**September 26, 2025
Addendum #2
FOR IMMEDIATE ATTENTION**

Reference – Invitation for Bid:	IFB #003-0-2026/SB
For Delivery To:	Menchville High School HVAC System Replacement
Bids Due:	Newport News Public Schools October 7, 2025 at 2:00 PM EST

ADDENDUM NO. 2

**HVAC Replacement
Menchville High School
Bid # 003-0-2026/SB
Newport News, Virginia
TCE #23-065**

TYPICAL POWER ROOF CHASE HOUSING PENETRATION DETAIL
 NOT TO SCALE

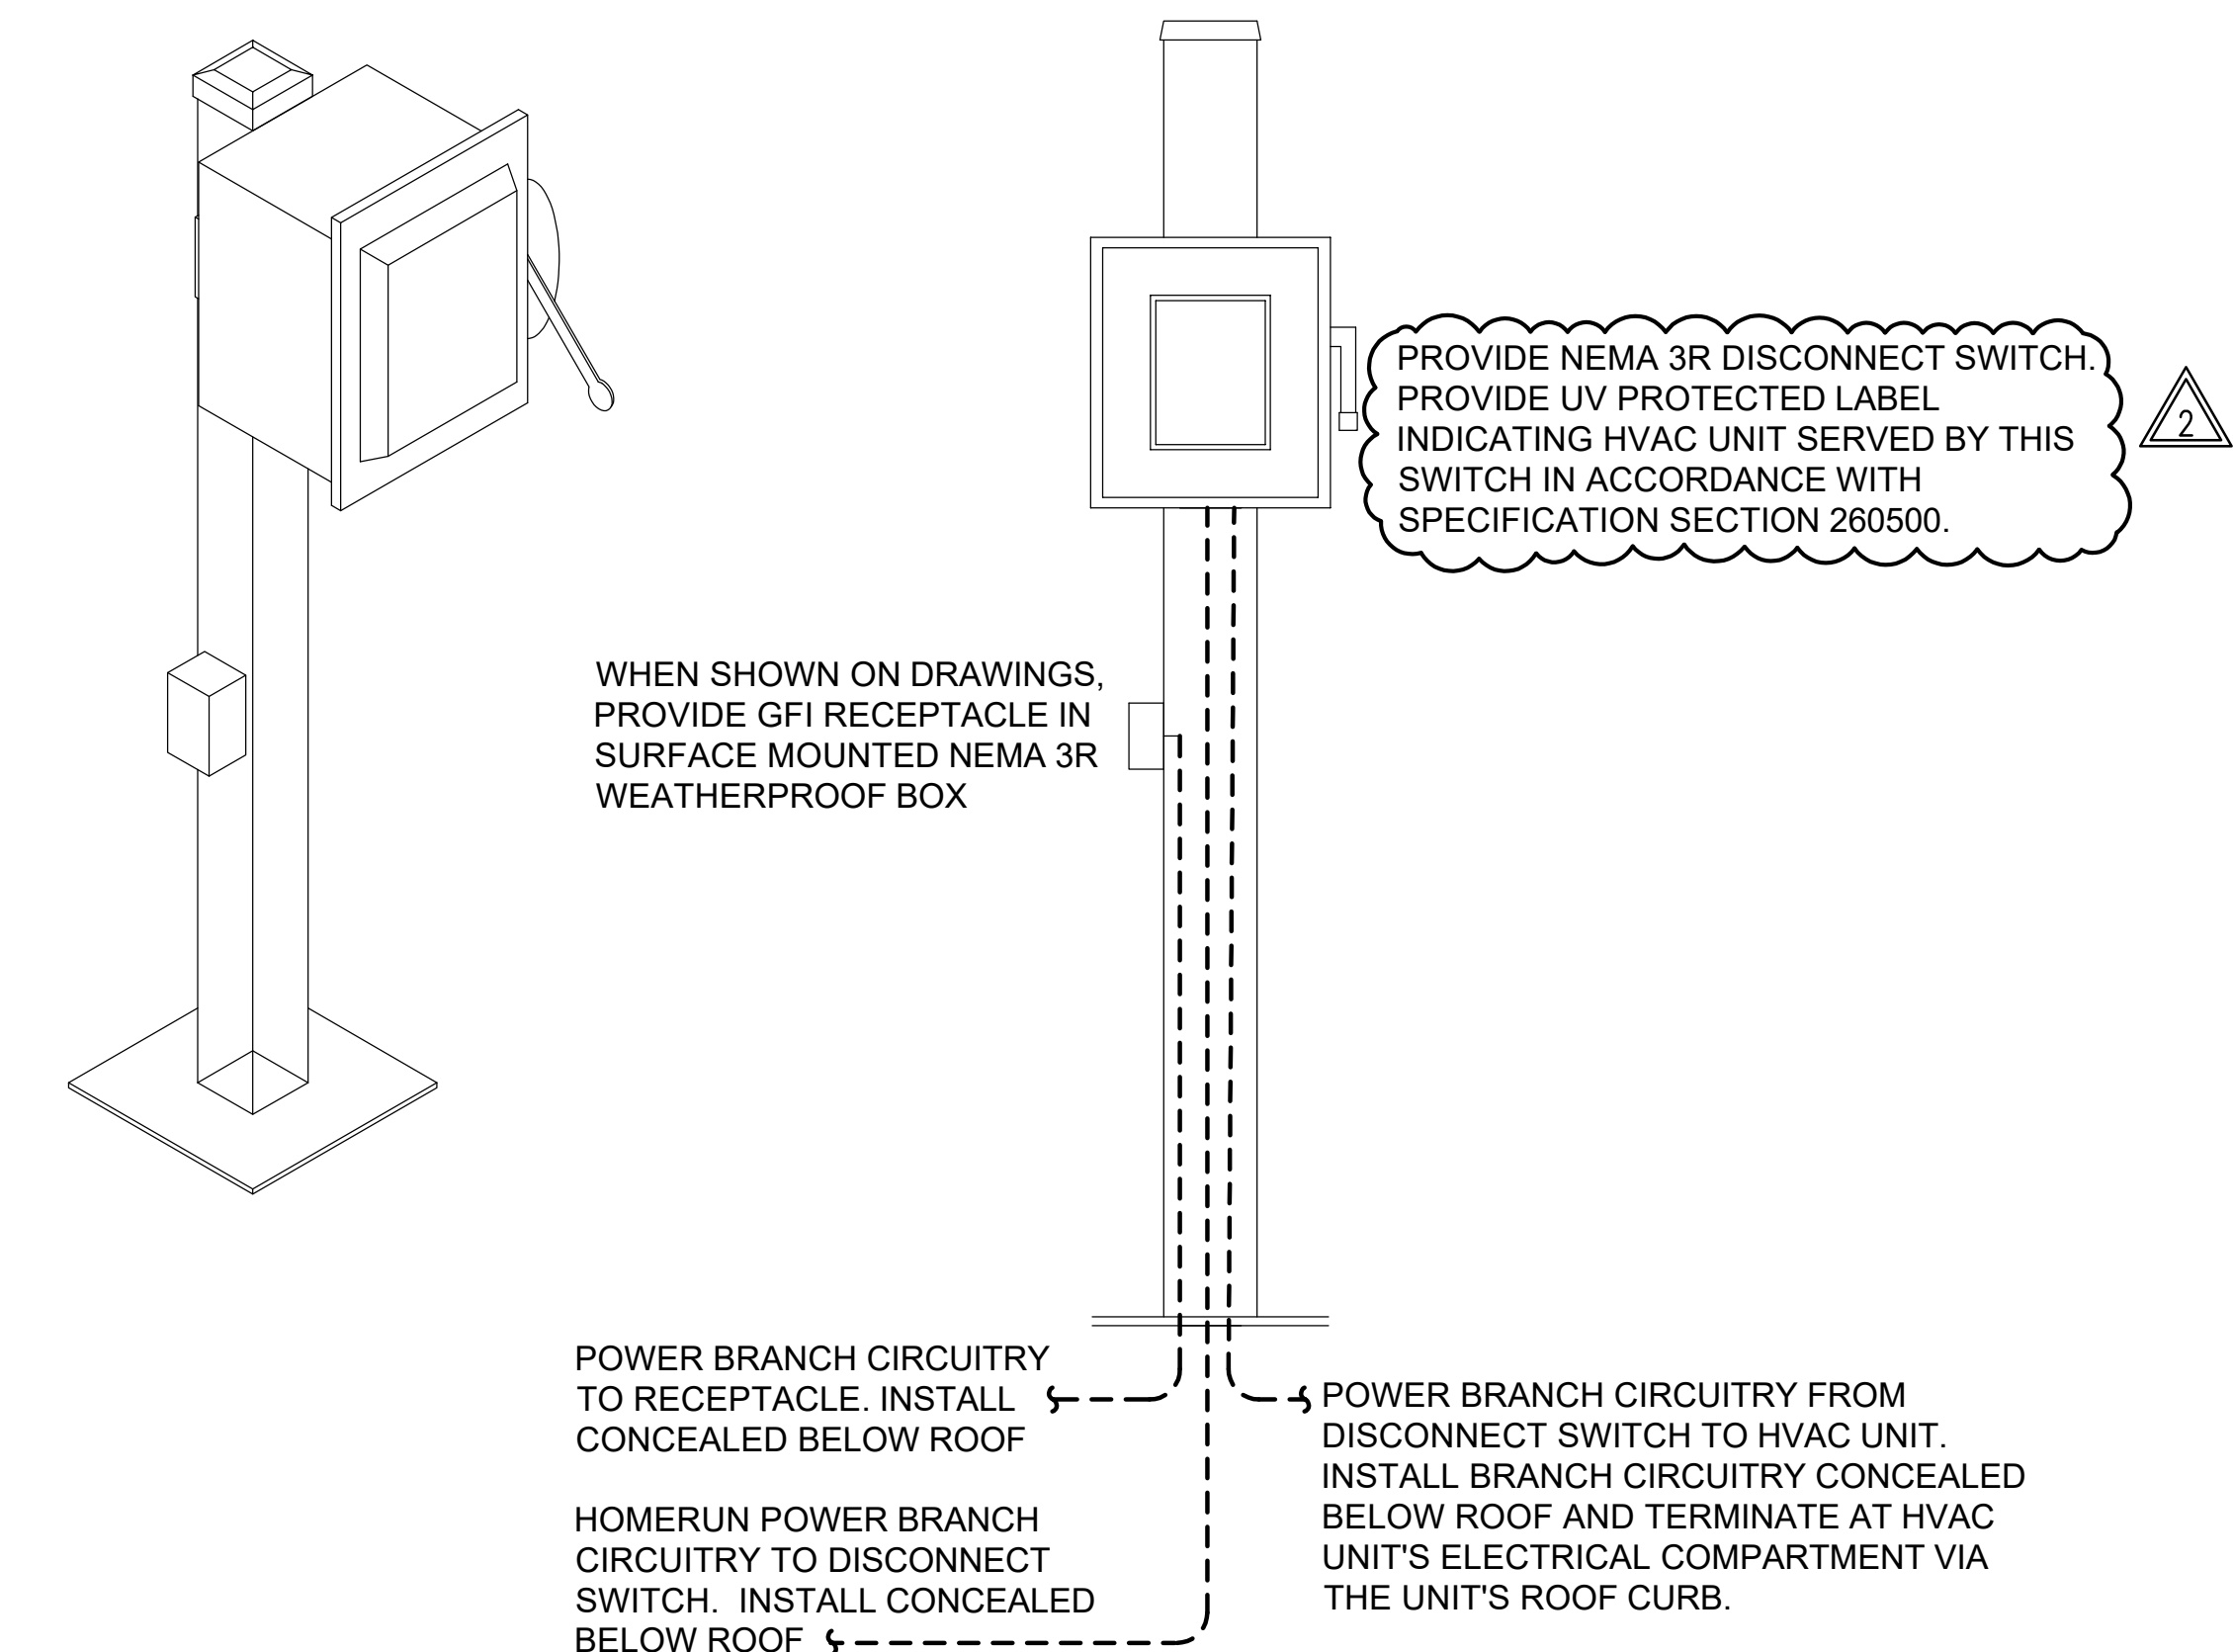
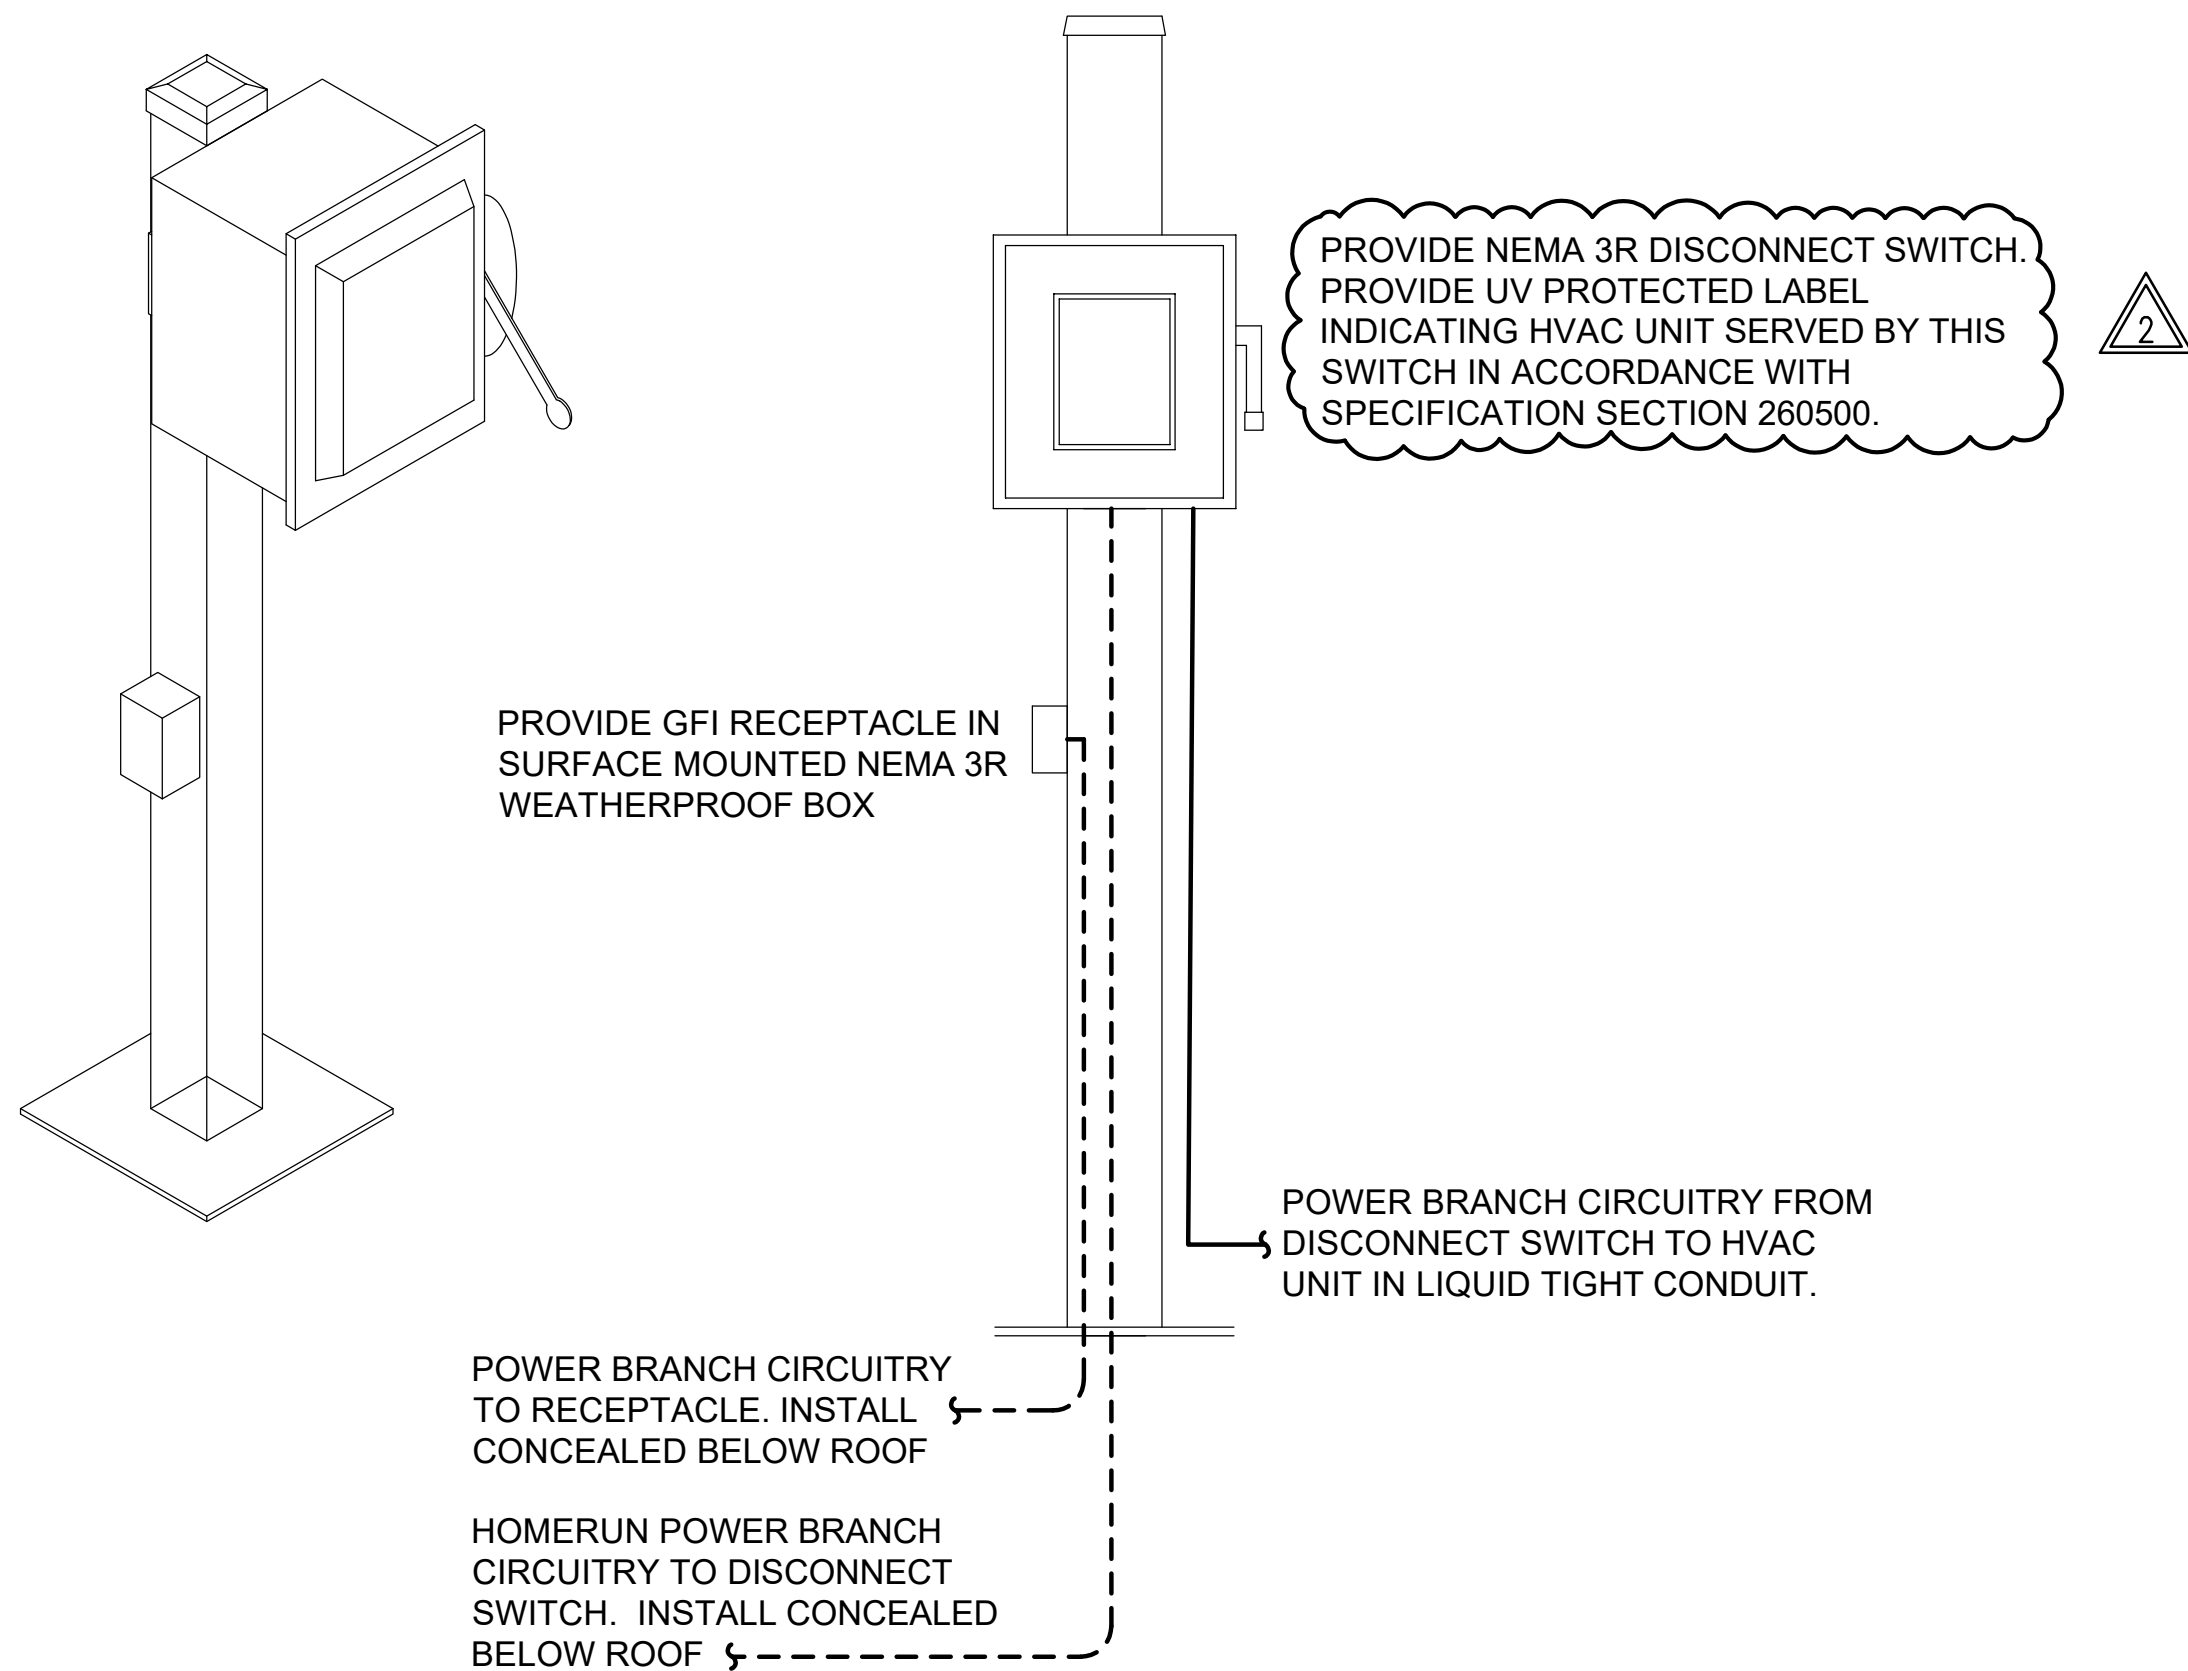
Sheet E-002:

- **CHANGE** Panel “BR1” to Panel “BR3”.

E-105

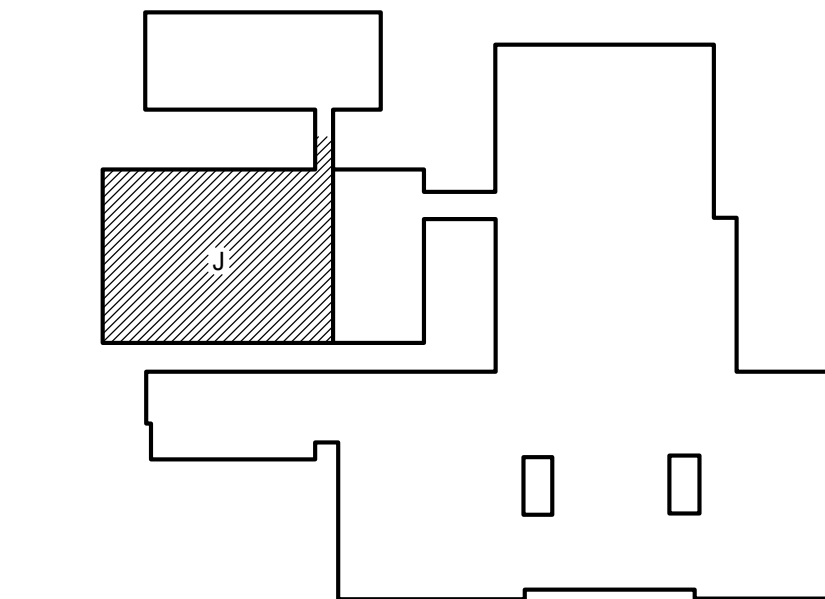
Sheet E-105:

- See revised drawing attached.

E-109

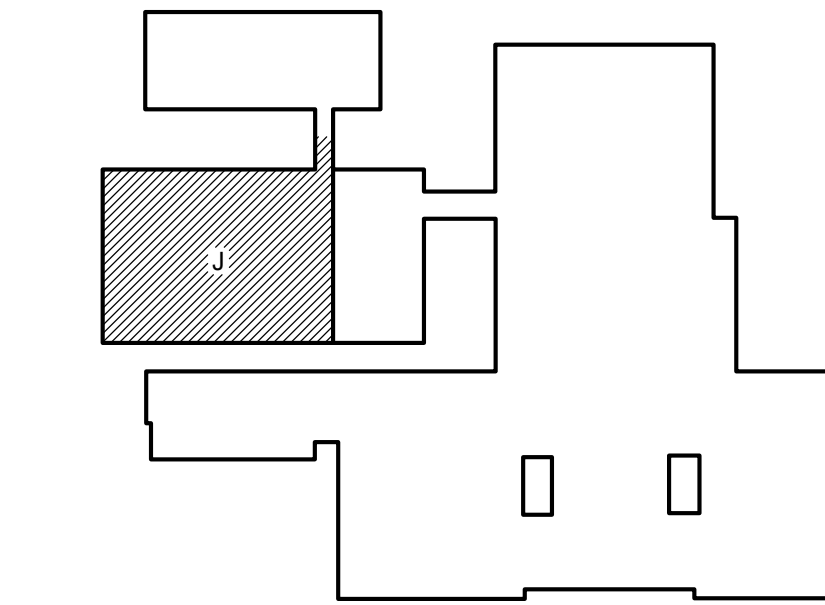
Sheet E-109:

- See revised drawing attached.

75. Drawing E-301 shows a new panel PDP-4.... Where is this panel to be installed? (I have not been able to find it on the drawings)

Answer: Pannel "PDP4" is in Room J241.
